Subject: [FIXED] Beam pipe valves?

1) [viewer.gif](#), downloaded 933 times

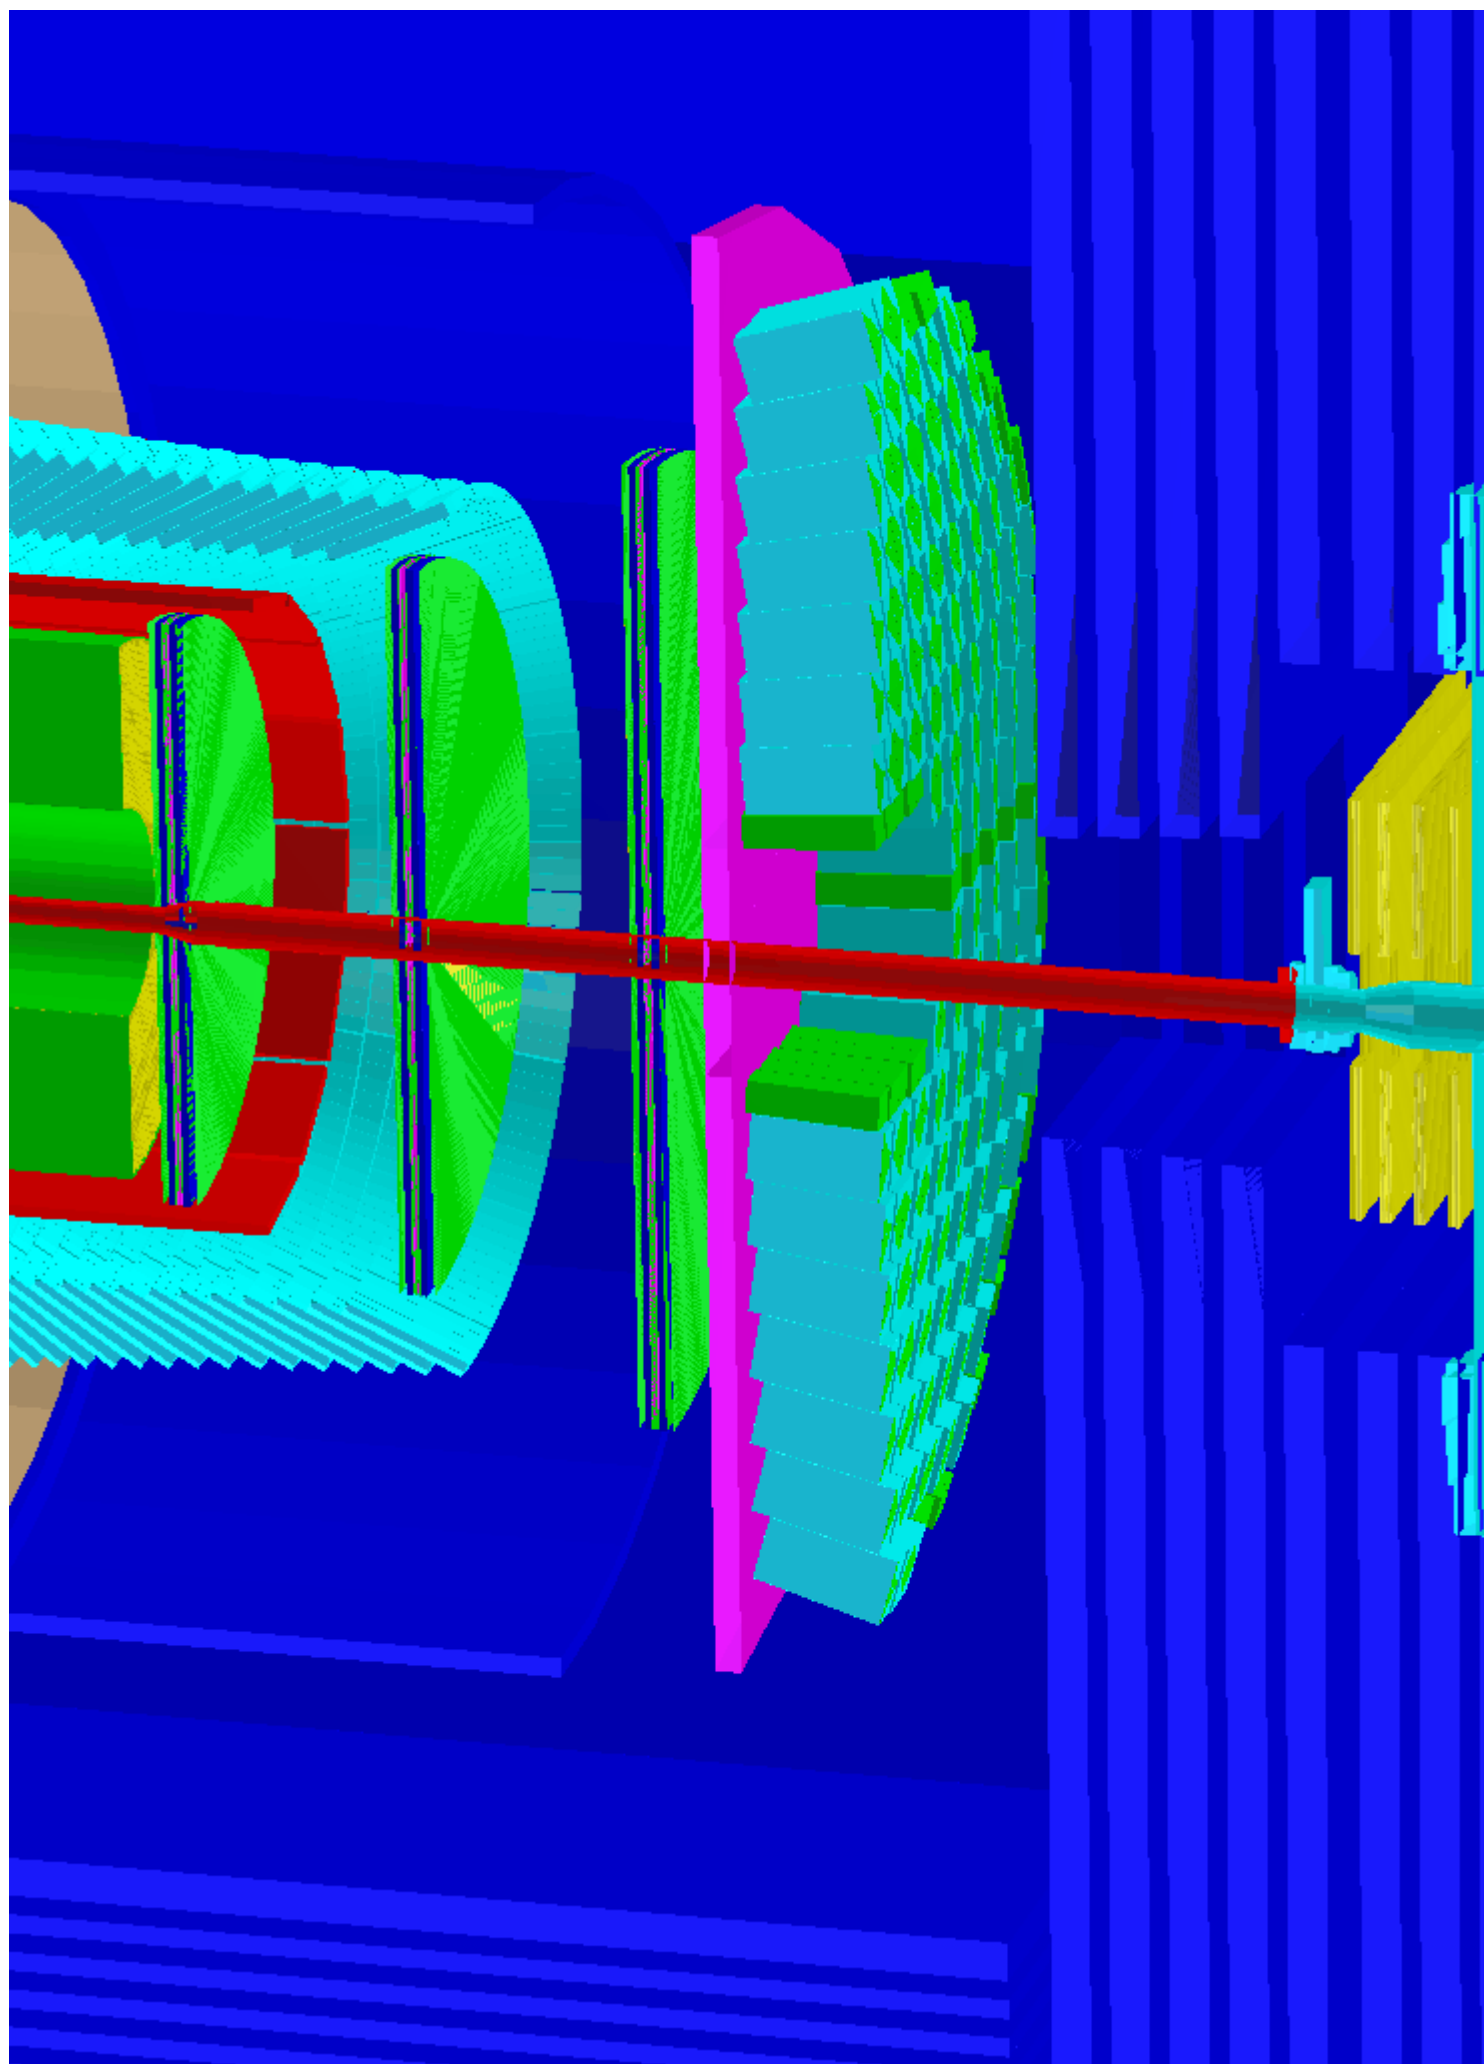
Dear all,
today I plotted the PANDA geometry and I have seen something strange:

In the OGL drawing you can see that the pipe has a sort of "tower" which is in the middle of the muon filter. I am wondering what is wrong there, if the "tower" should be really there, if maybe the muon filter should be modified to host it, or if maybe we have some geometry problems.

Indeed, this is the first pumping station downstream of the target. The description corresponds to what is to be found on EDMS since several years. So I guess that muon description is not up to date?

Fixed!
